Omaha Public Schools Department of District Operational Services Purchasing Division

BID No.: **25-029** Date: June 05, 2025

Addendum No. 2 to Bid Documents for OPS Mills Electrical Service Replacement

OPS MILLS ELECTRICAL SERVICE REPLACEMENT

Item #1: A1-0 Basement Floor Plan:

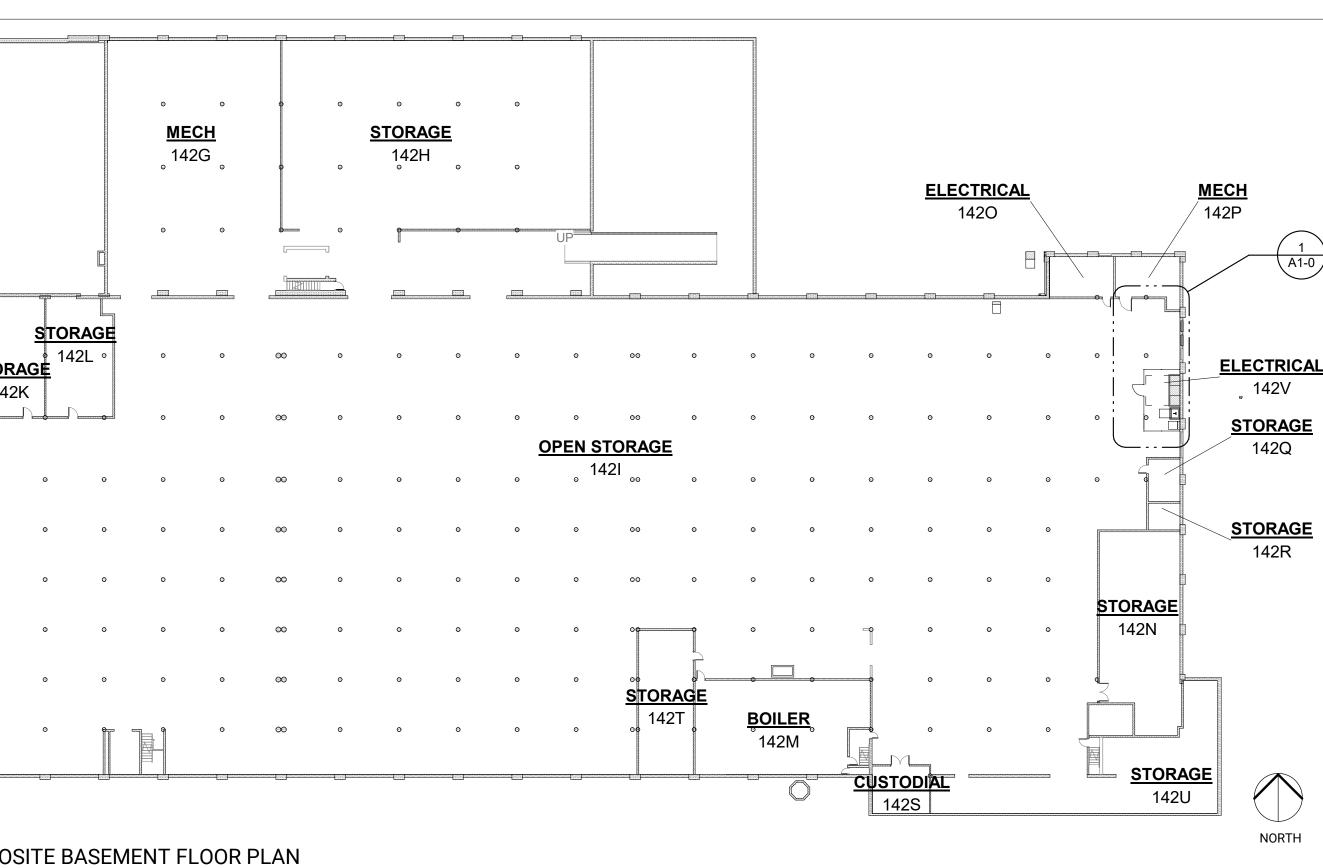
- a) Selective Demolition
 - a. Selective demolition image was updated to remove the red fill over the DMARC panel. The contractor is to maintain this DMARC in the basement and provide a fabricated cover for the panel.
 - b. The demolition of the panel to the north is to be coordinated with OPS staff before removal.
